**SITE PLAN REVIEW SHEET
ENVIRONMENTAL VARIANCE REQUEST ONLY**

CASE: SP-2017-0176D

PROJECT NAME: 1704 & 1706 Channel Road

The applicant requests the following: To allow cut above 4' within Lake Austin [25-8-341(A)]

ATTACHMENT 3
PROPOSED CONDITIONS

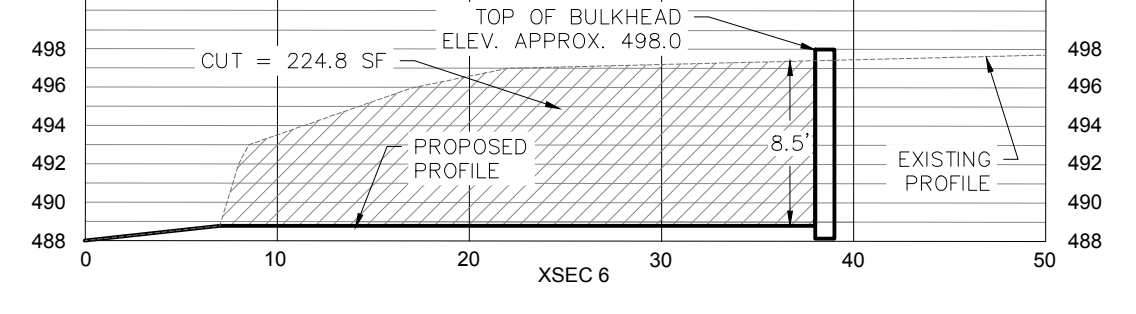
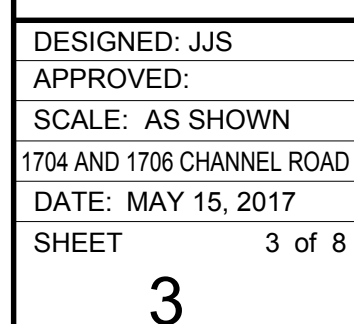
No, there is an existing cut in slip and other places along the shoreline that the boat dock could be located.

No, the development proposed is not based on a hardship but rather a preference for the boat dock location.

No, there is an existing cut in slip and other places along the shoreline that the boat dock could be located. It is unnecessary to deviate from code since other options exist.

Yes, the project is enhancing the floodplain but any disturbance could be deemed harmful.

Yes, there will be disturbance but it would be contained within a silt boom and the sediment would settle out eventually.

Clearly indicate in what way the proposed project does not comply with current Code (include maps and exhibits)	<i>Enlarging the cut-in slip will require cut more than 4 ft. Attachment 3, Proposed Conditions, shows the cross-sections detailing the cut across the proposed cut-in slip. In order for a boat dock to house a ski boat and boat lift, it's necessary to have 3.5 ft of depth to accommodate the draft of the ski boat and cradle of the boat lift. The slip will extend into what is now land which is about 4 ft higher than the water surface elevation; so the depth of the cut is the sum of the height difference between the land elevation and the water surface elevation plus 3.5 ft. for the boat draft.</i>
---	---

- Bring the floodplain rating from a "Poor" rating to an "Excellent" rating
- Remove the old submerged dock and posts, as well as one of the existing fishing piers
- Increase tree planting plan with at least a 5" trunk Pecan Tree as directed by the City Arborist
- Any increase to the fishing pier will require approval by the Environmental Commission
- All conditions will be added to the cover sheet of the permit set.
